Planning Commission Staff Report

Project Type:	Site Development Plan
Meeting Date:	May 29, 2019
From:	Andrew Stanislav, Planner <i>AS</i>
Location:	15320 Conway Road
Description:	<u>SMS Group (15320 Conway Road):</u> A Site Development Plan, Landscape Plan, Lighting Plan, Architectural Elevations and Architect's Statement of Design for a 0.93 acre tract of land zoned "PC" Planned Commercial District located on the south side of Conway Road approximately 500 feet west of its intersection with Chesterfield Parkway East (18S310348).

PLANTING PLAN FOR THE PROPOSED
15320 Conway Road
 CHESTERFIELD, MISSOURI

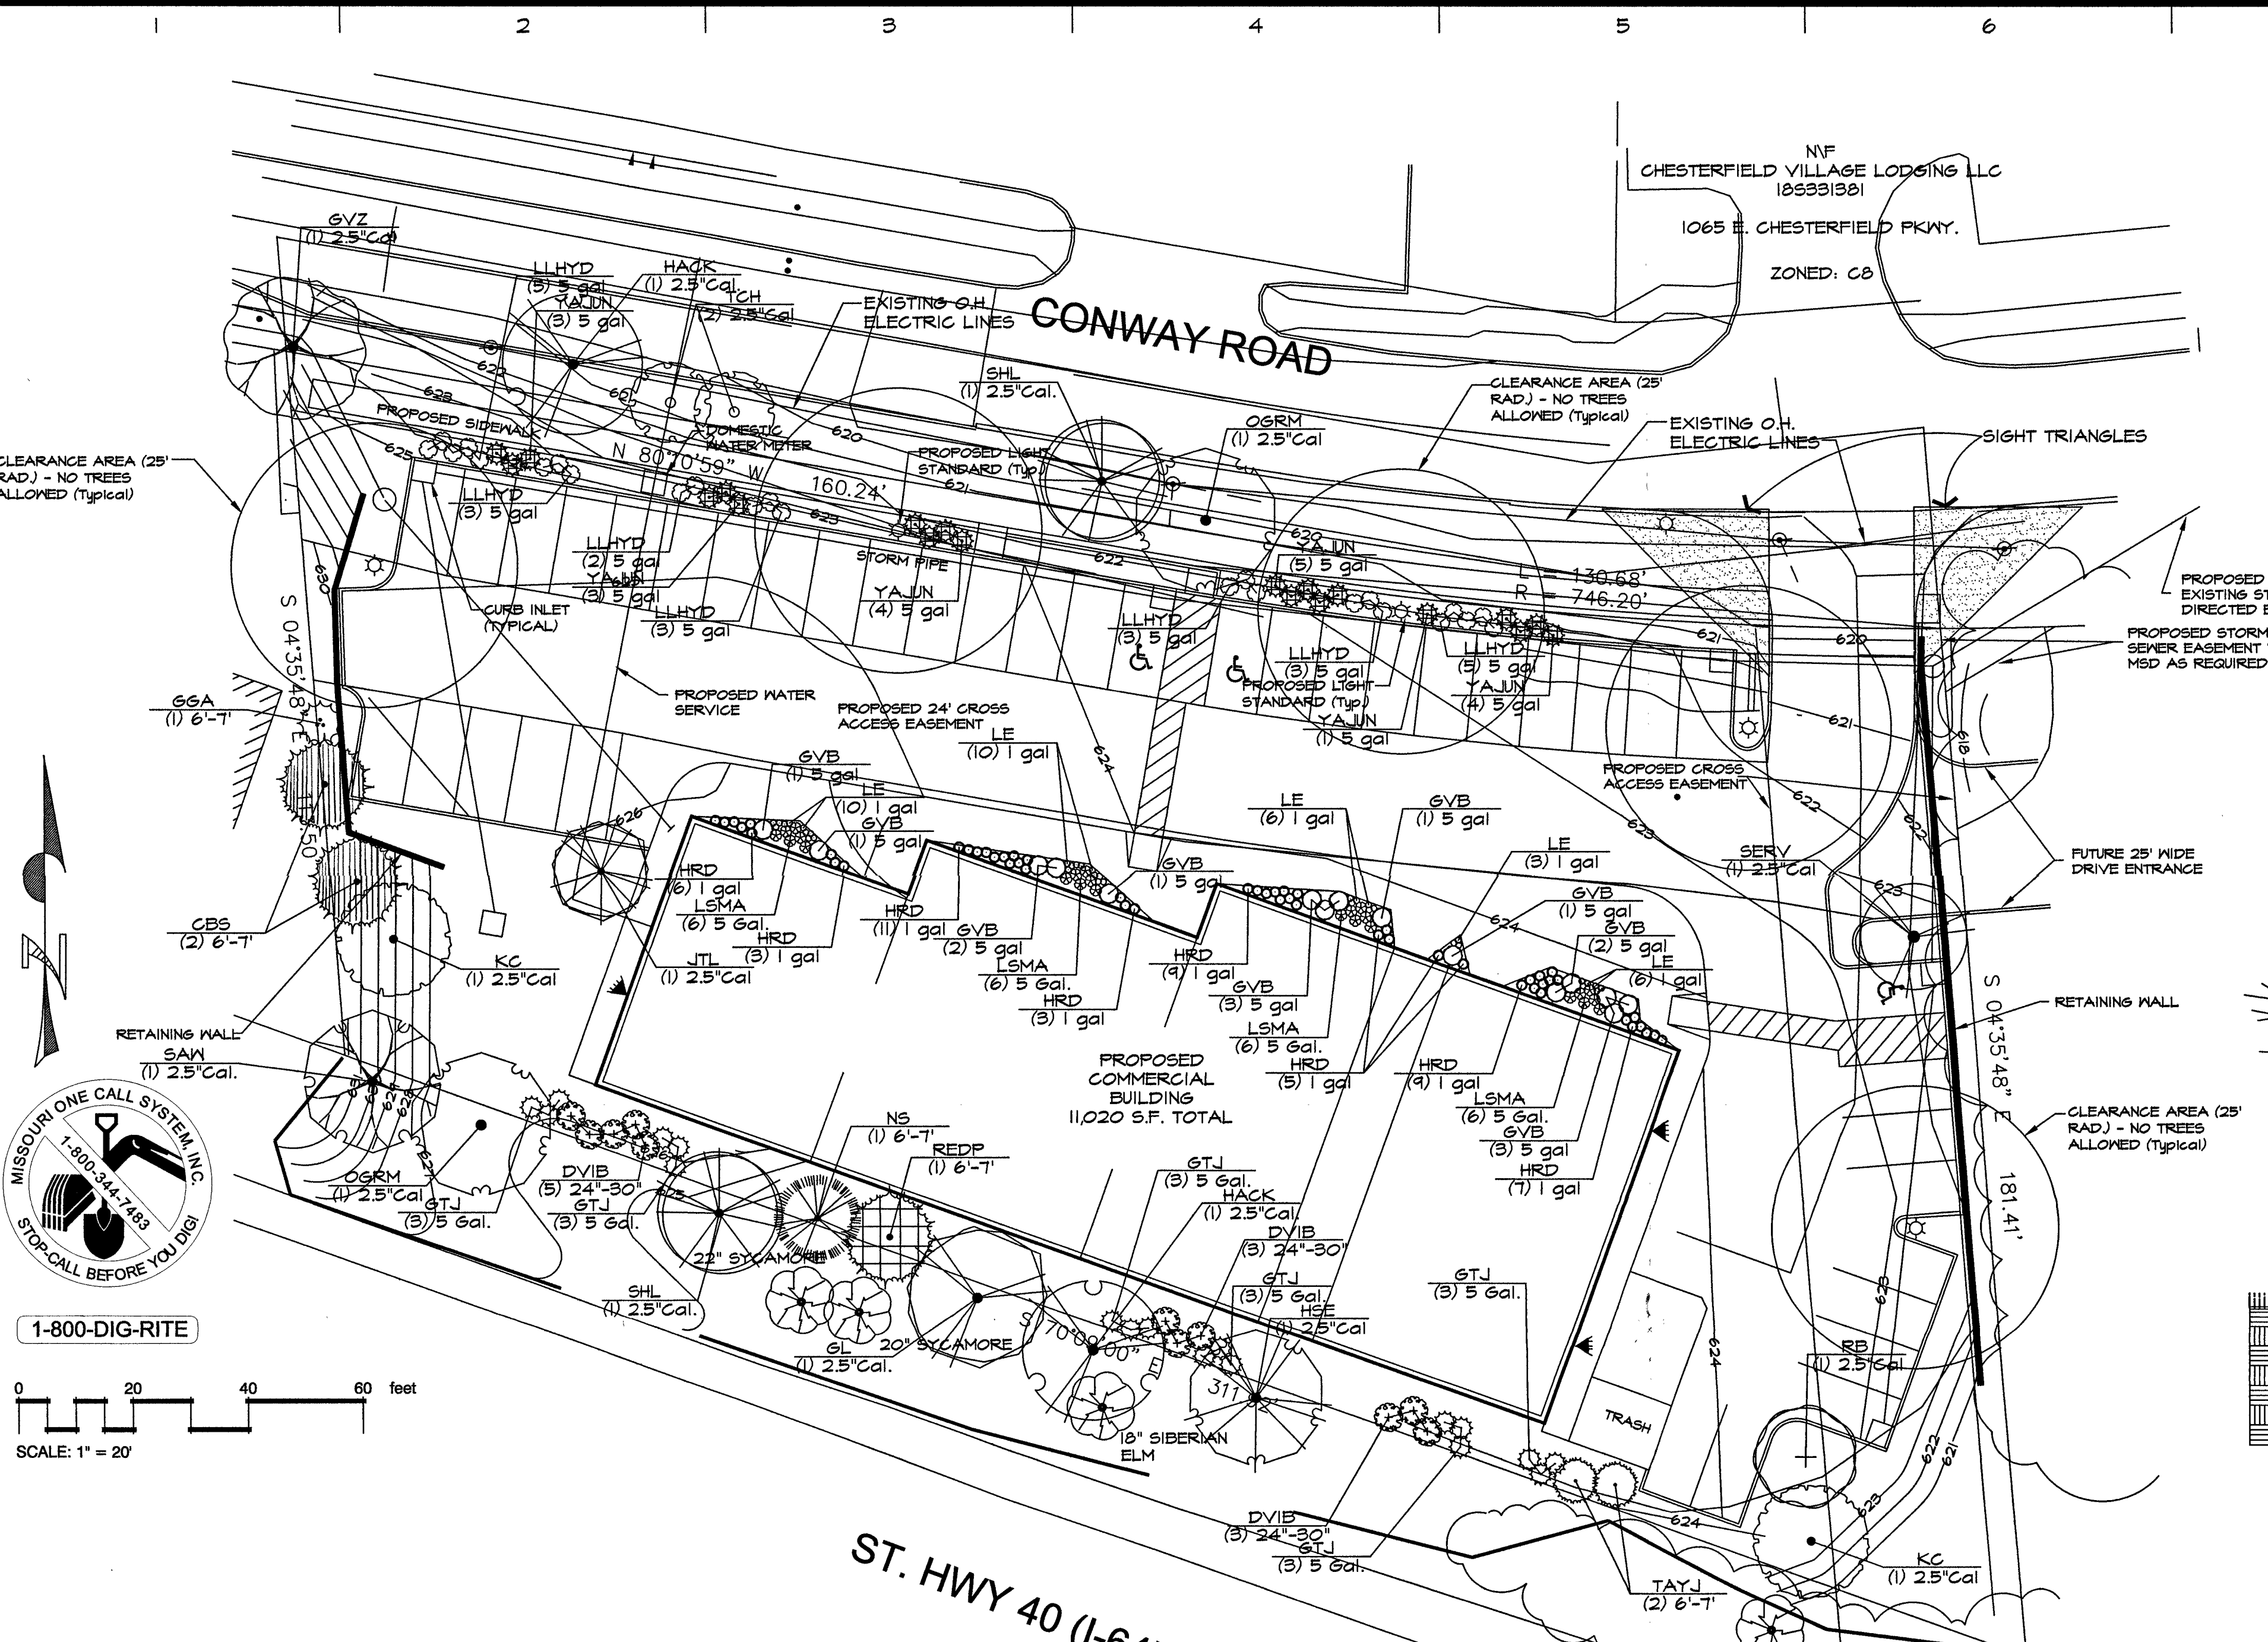
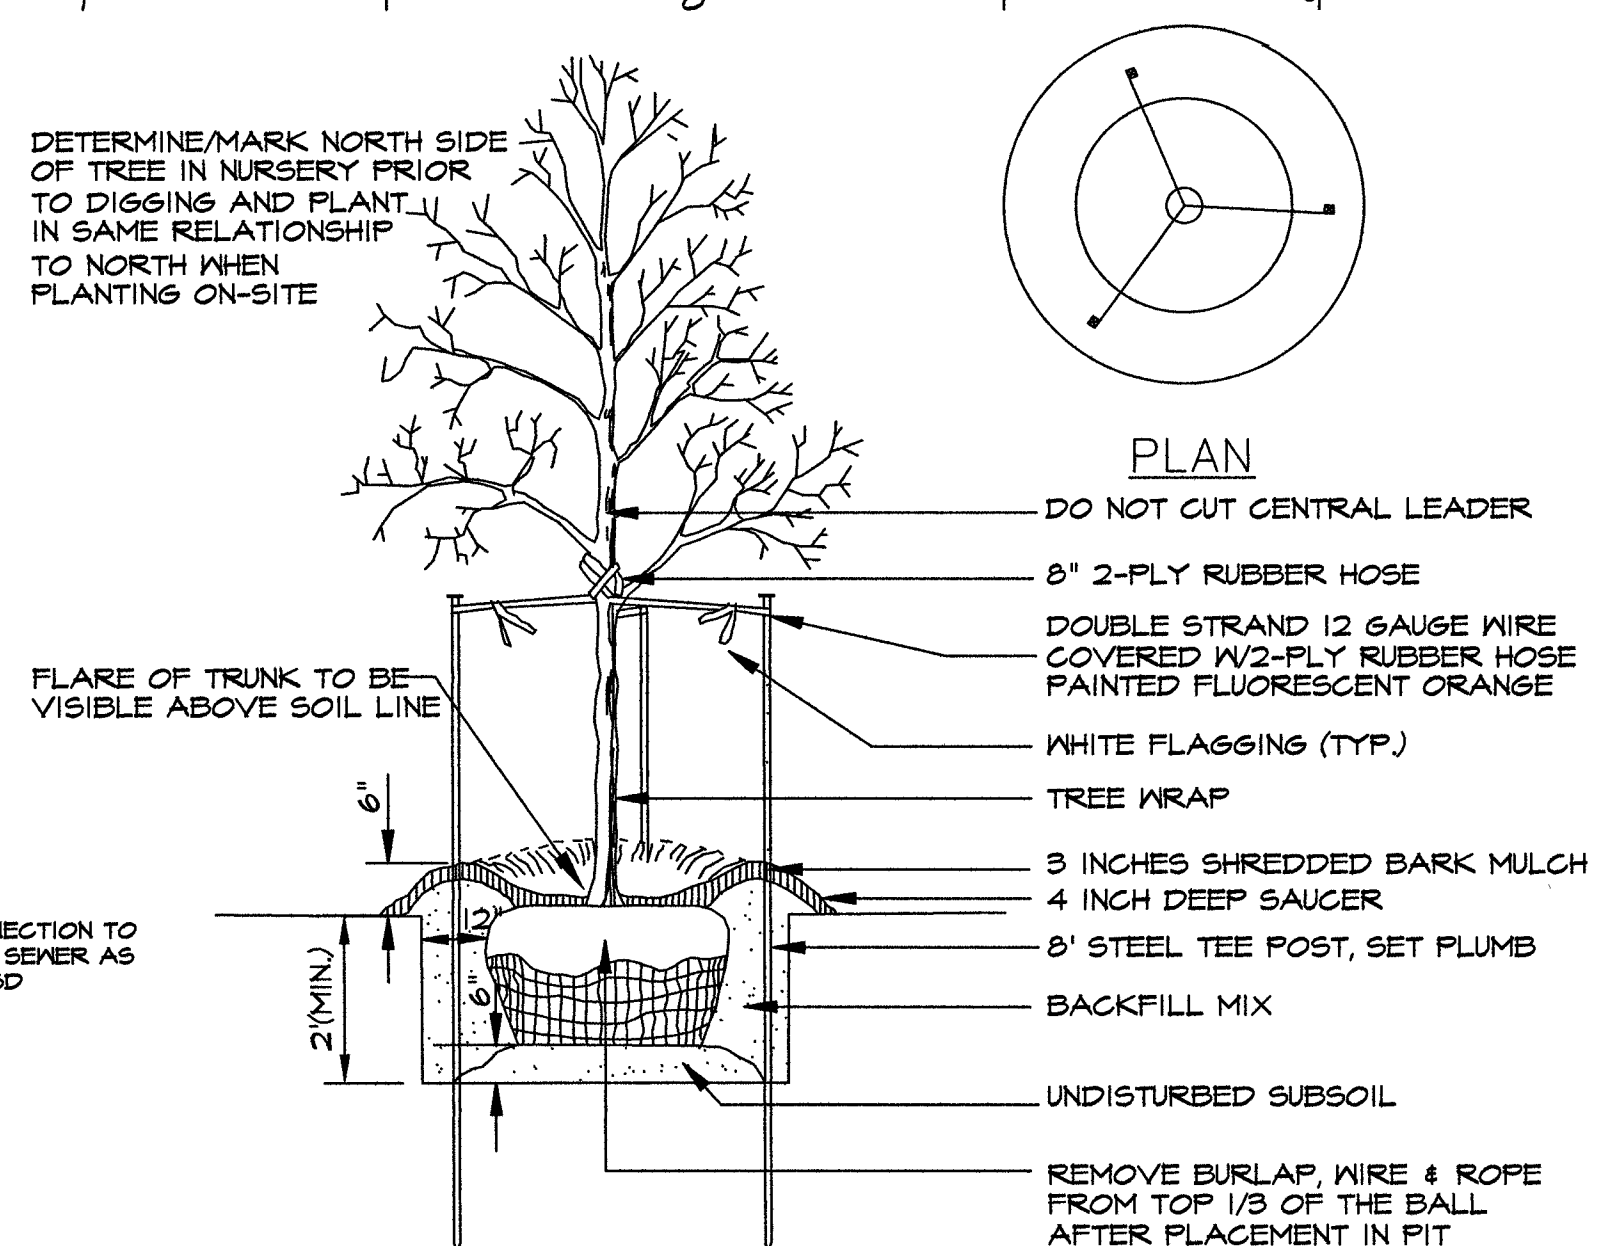
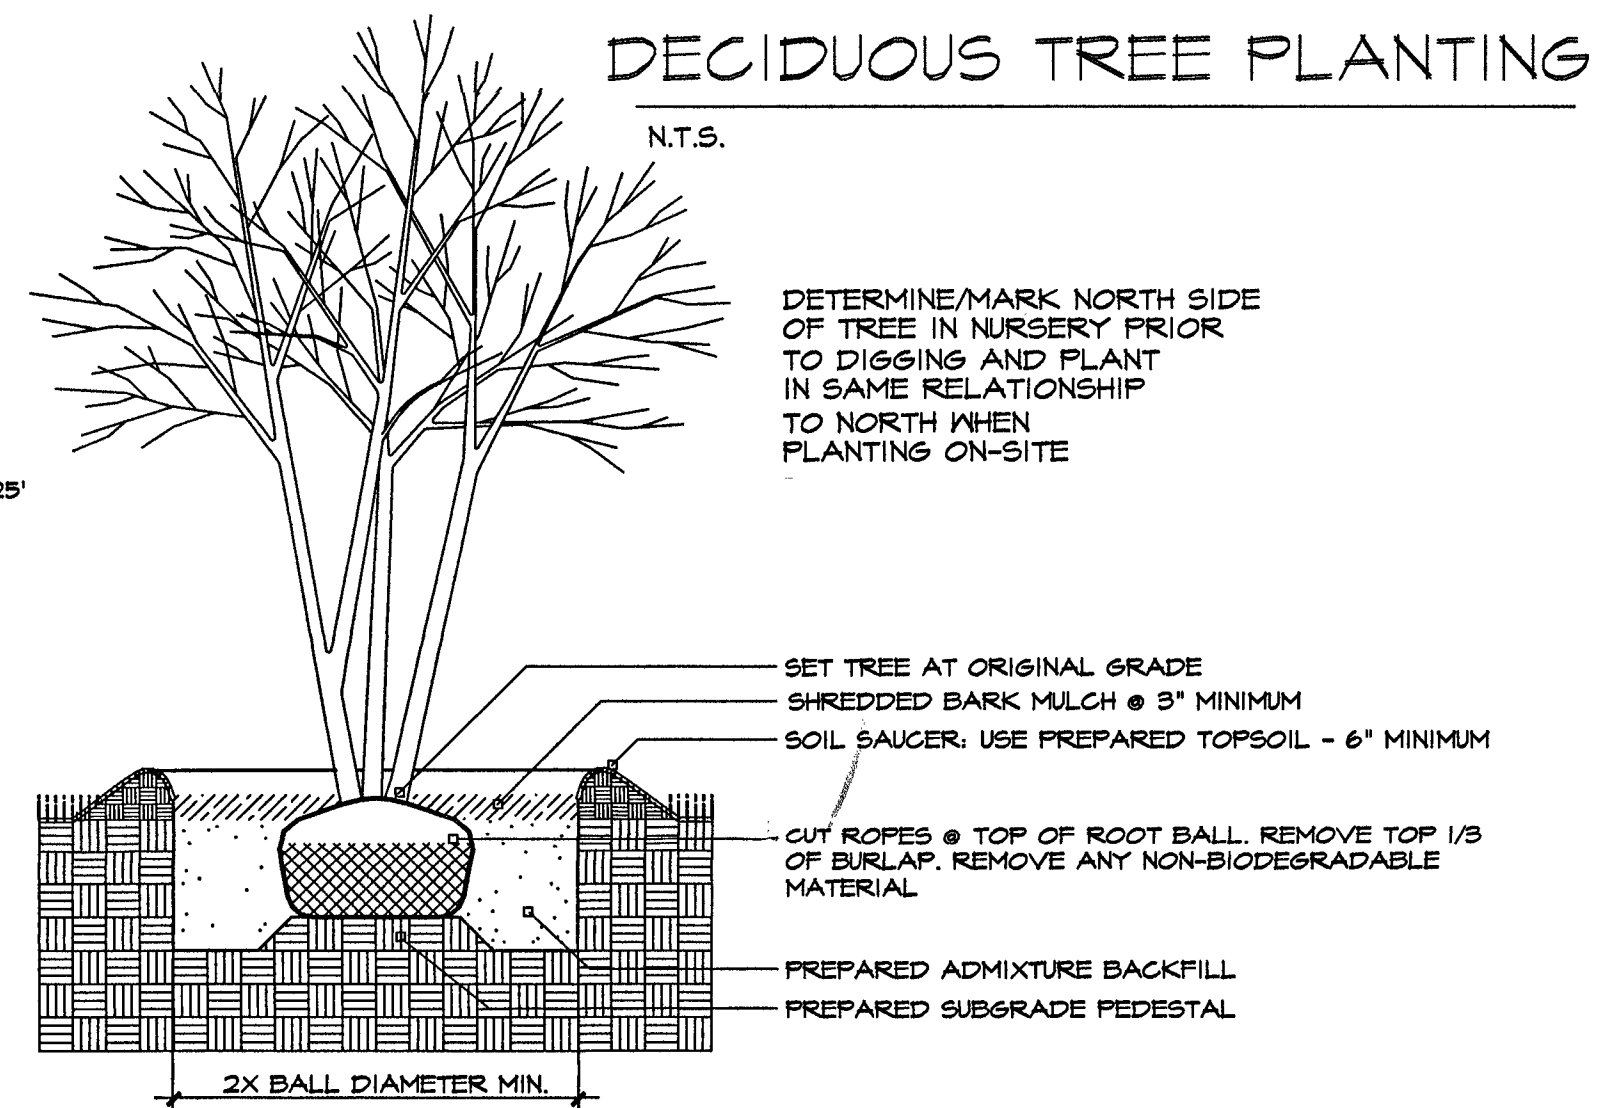
- **Add landscaping to the north side of the building to soften the appearance, as presented in the rendering. Revise the landscape plan accordingly.**

The proposed landscape plan has been revised to incorporate plantings on the north façade facing Conway Road as depicted in the building rendering.

Figure 5: Proposed Building Elevations

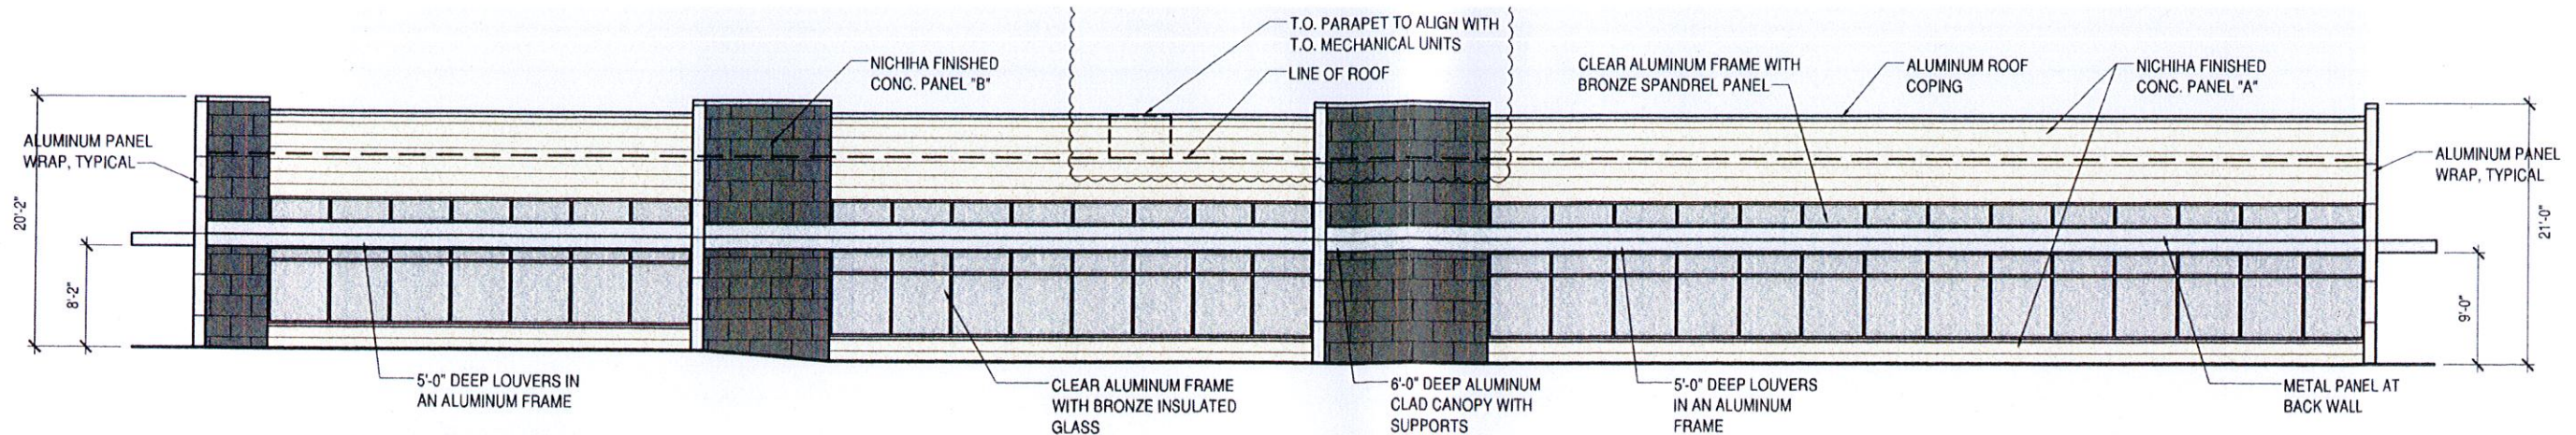
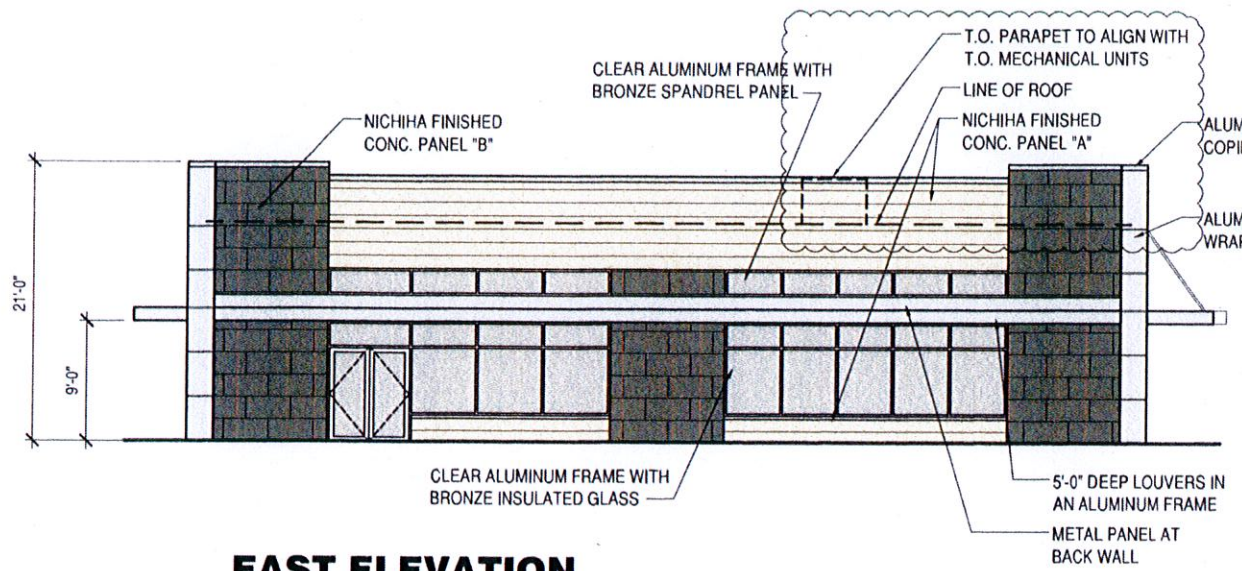
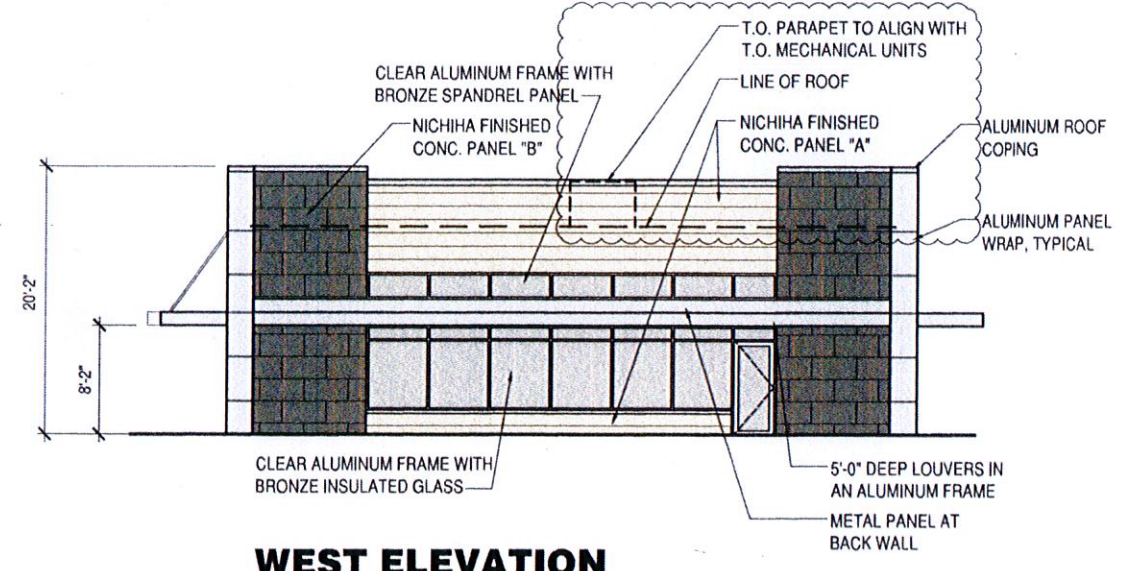
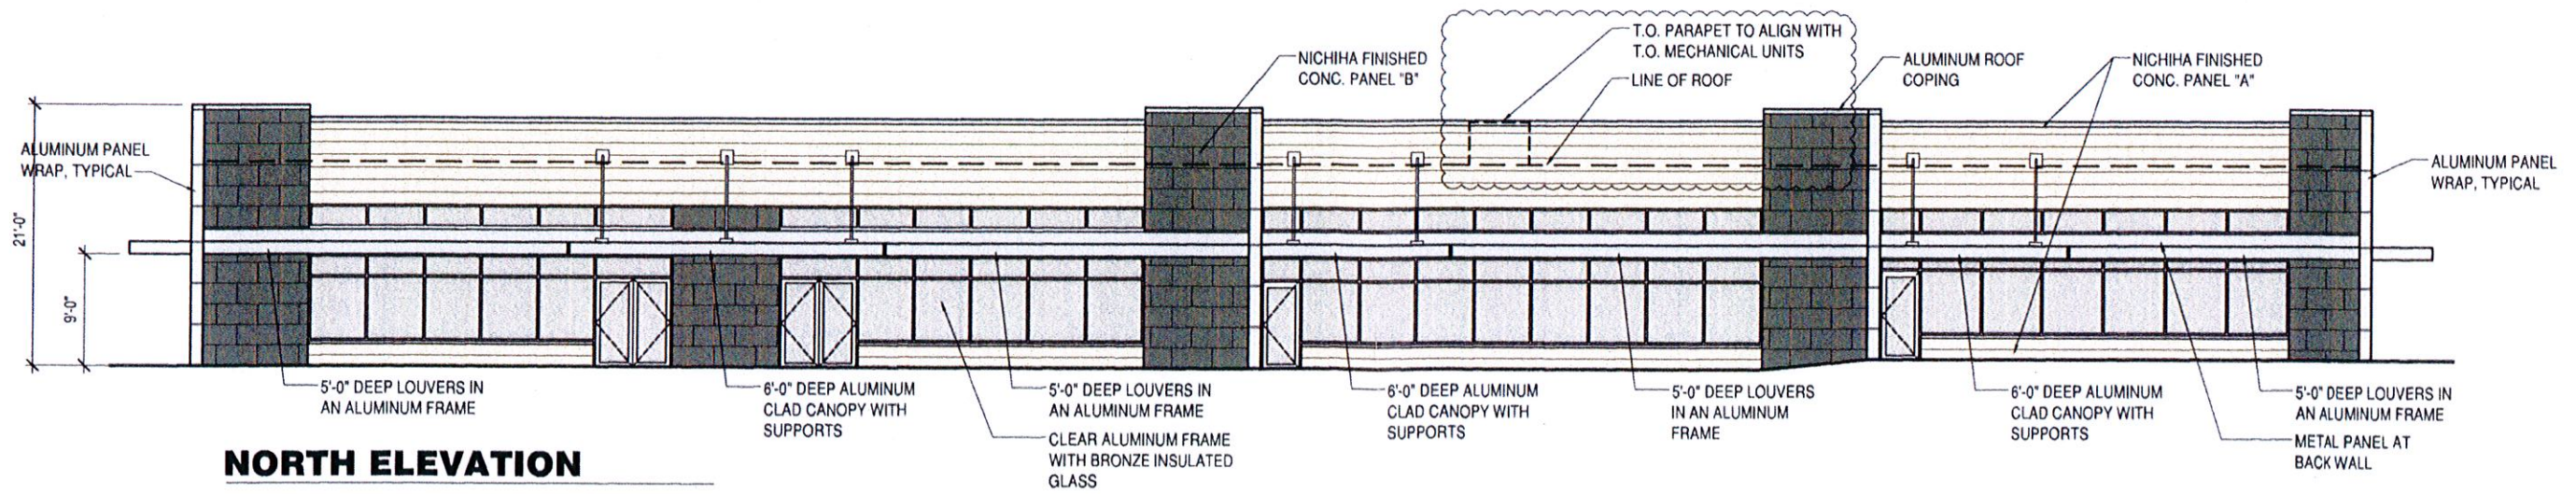
- **Due to the high visibility of the site, ensure mechanical equipment is placed to be adequately screened. The height of the roofline should be delineated on the building elevations.**

- **The color elevations and renderings should be revised to better reflect the materials being utilized, specifically the bronze windows.**

The building elevations have since been revised to include the requested information and depicts the roofline, mechanical unit location, and top of parapet walls.

Proposed exterior materials are labeled on the building elevations and sample images are included for each finish.
